Public comment response

January 2, 2026

Re: Project File #608020 Cape Cod Bridges Project

Figure 2 - Location of proposed overpass versus existing path plan

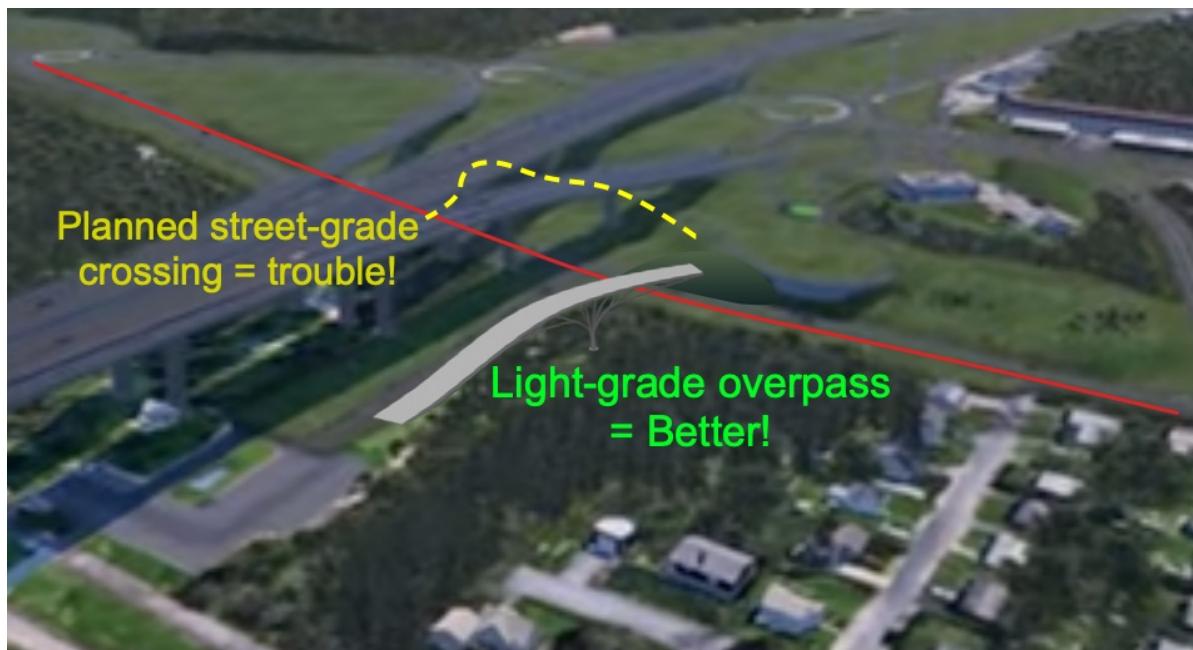
A light, ramped, grade-separated bike & walker overpass is a simple cost-effective solution that **eliminates the problems entirely**. An overpass can leverage existing site elevation and the already-planned retaining wall to descend towards the canal into the Bourne Recreational Area. Figure 2 illustrates this.²

This overpass constitutes a reasonable design alternative that meets the project's purpose and need while reducing adverse effects on both the human and natural environment. The benefits are clear:

- **Improves safety unequivocally.** The overpass entirely removes the interaction between bikes, walkers and drivers.
- **Further encourages usage.** Eliminating fear of car collisions makes all users happier, resulting in increased year-round use by locals and visitors.
- **Better supports event surges.** Large-scale events can proceed without closing the road or requiring law enforcement control. Smaller events will be feasible because hiring police traffic control will not be needed.
- **Simplifies canal bike path connection.** The overpass can safely exit near most users' destination - the bike path.
- **Improves site impact.** Utilizing existing right-of-way maintains land alignment, leverages the descending elevation, and eliminates extra berms and erosion control.

To support informed decision-making under NEPA, we respectfully request that **massDOT prepare a preliminary design and comparative cost estimate** (capital and operating) for the proposed lightweight overpass, sufficient to evaluate it as a **reasonable alternative** to the planned at-grade crossing. This assessment would allow massDOT to determine whether the overpass better meets the project's purpose and need while reducing reasonably foreseeable adverse effects on the human and natural environment.

Figure 3 - Descent grade eliminated

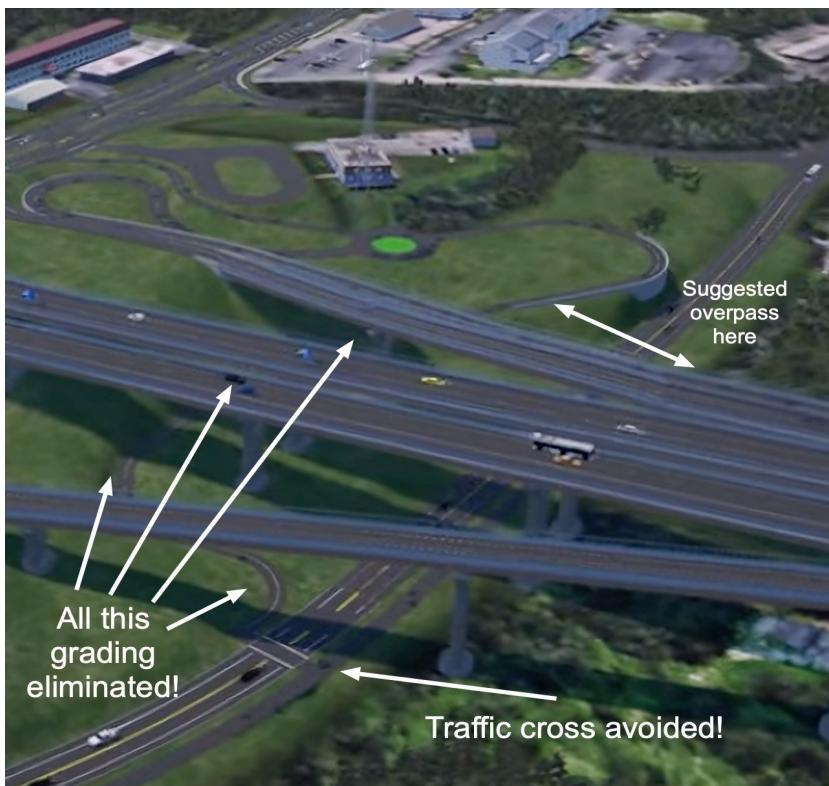
- **The change leverages planned structures.** A structural berm and major path descent are already included in the current plan; these elements can be reworked to form the southerly approach to an overpass. The actual overpass can be a light, non-vehicular structure.
- **No new property required.** The northern side of the overpass, which constitutes the descent over grade, can descend into the

existing Bourne Recreation Area and Cape Cod Canal District property. No property taking is required. See rough placement illustrated in Figures 3 & 4.
